14. DESCRIPTION OF AMENDMENT/MODIFICATION (Organized by UCF section headings, including solicitation/contract subject matter where feasible) AMENDMENT NO. 0005 to DACA65-02-R-0012, Aerial Delivery and Field Service Training Facility, Fort Lee, VA. Technical specifications are amended. Make appropriate changes in accordance with the attached.						
15A. NAME AND TITLE OF SIGNER (Type or print)				16A. NAME AND TITLE OF CONTRACTING OFFICER (Type or print)		
15B. CONTRACTOR/OFFEROR		15C. DATE SIGNED		16B. UNITED STATES OF AMERICA		16C. DATE SIGNED
_____ (Signature of person authorized to sign)		BY _____		_____ (Signature of Contracting Officer)

AMENDMENT 5

AERIAL DELIVERY AND FIELD SERVICES TRAINING FACILITY _ PHASE I

Hoist Assembly Detail:

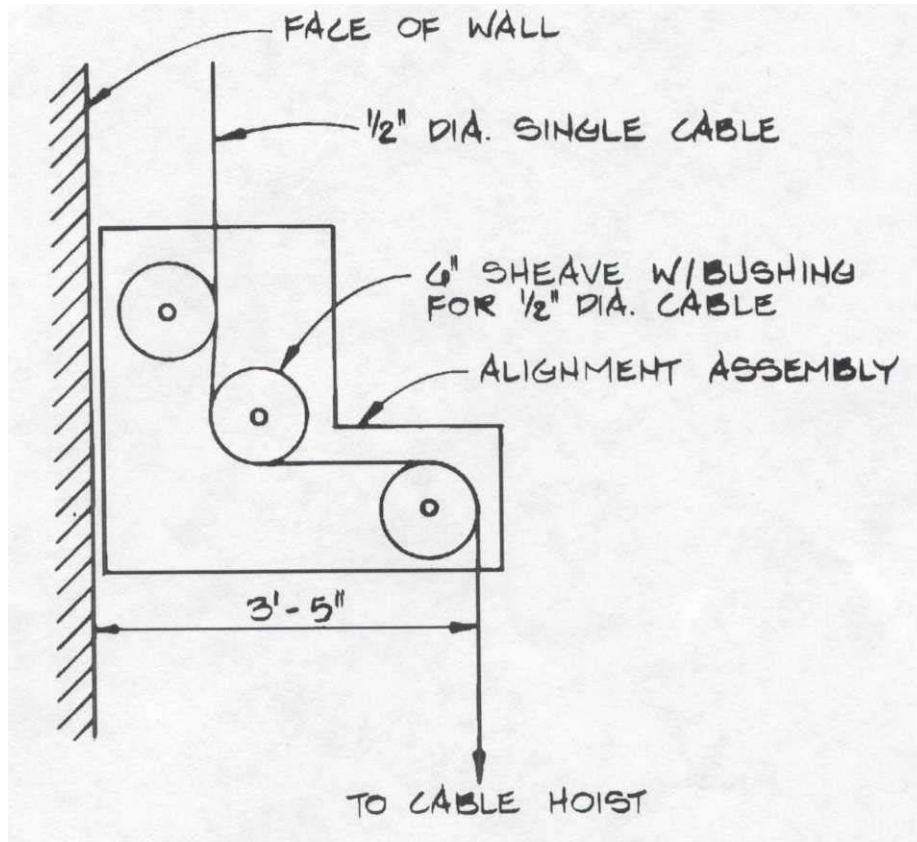
Drawing A432 - B-5, Add detail, “ Hoist Assembly Detail”, see below.
